Appendix I of RNTPC
Paper No. A/NE-SLT/5A

**APPLICATION FOR PERMISSION
UNDER SECTION 16 OF
THE TOWN PLANNING ORDINANCE
(CAP.131)**

S 16 Planning Applications no. A/NE-SLT/5

Green Power's Comments Regarding Planning Application A/NE-SLT/5

Figure 1. Photo taken in September 2023, showing the big trees on both sides of the path where the proposed alignment would follow.

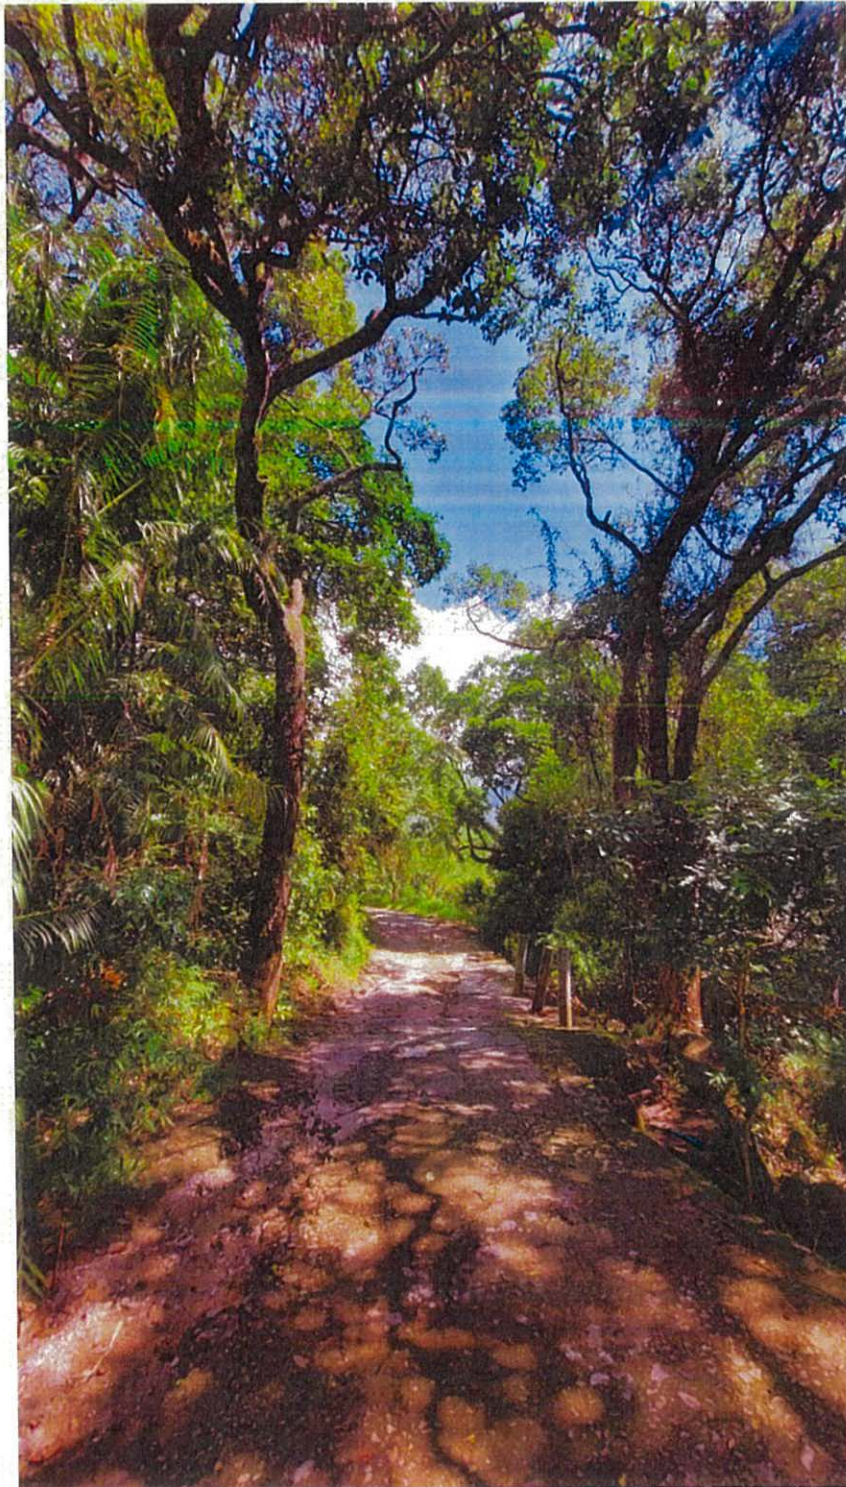
- The alignment would still be very close to the woodland edge including some mature trees (see **Figure 1**). Has the applicant proposed any measures to protect the root system of these trees? Is hand digging enough? Is the proposed depth (about 0.51 m) excessive? Can it be shallower? Has any other methodology been considered like pneumatic soil trenching?

Figure 1 The work section in SSSI lies very close to the natural stream which is “Ecologically Important Stream” (EIS) (marked in blue). We are very concerned that polluted and muddy runoff would be directly discharged into this EIS.

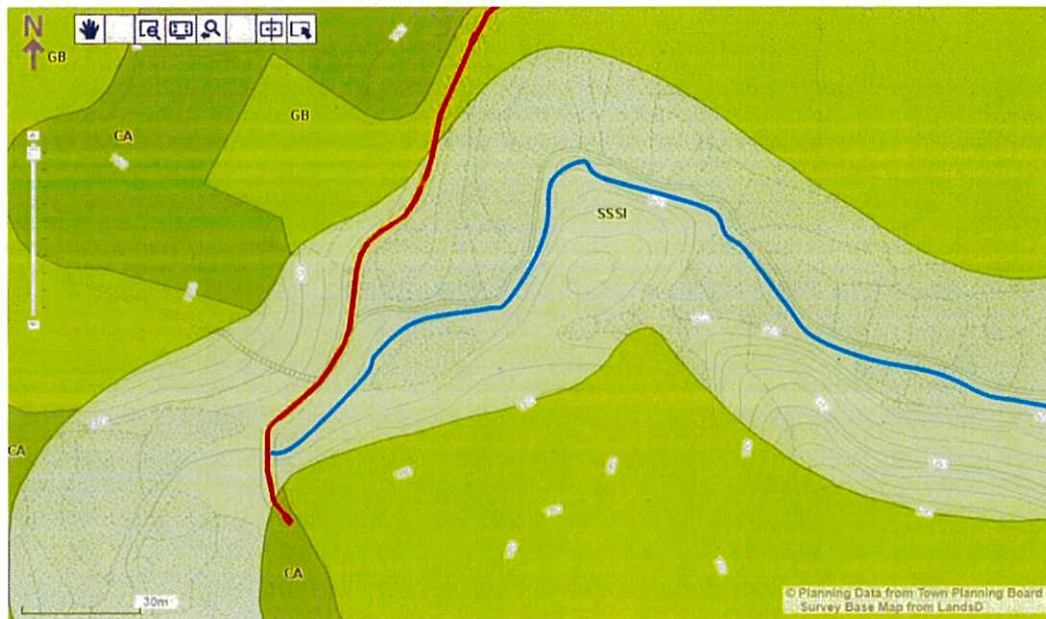
The work section in SSSI lies very close to the natural stream which is “Ecologically Important Stream” (EIS) (Figure 1). We are still very concerned that polluted and muddy runoff would be directly discharged into this EIS. While all pipe works, according to the planning application, would be conducted by hand digging except the section in SSSI, it would be necessary to clarify how runoff arise from construction work can be handled in proper.
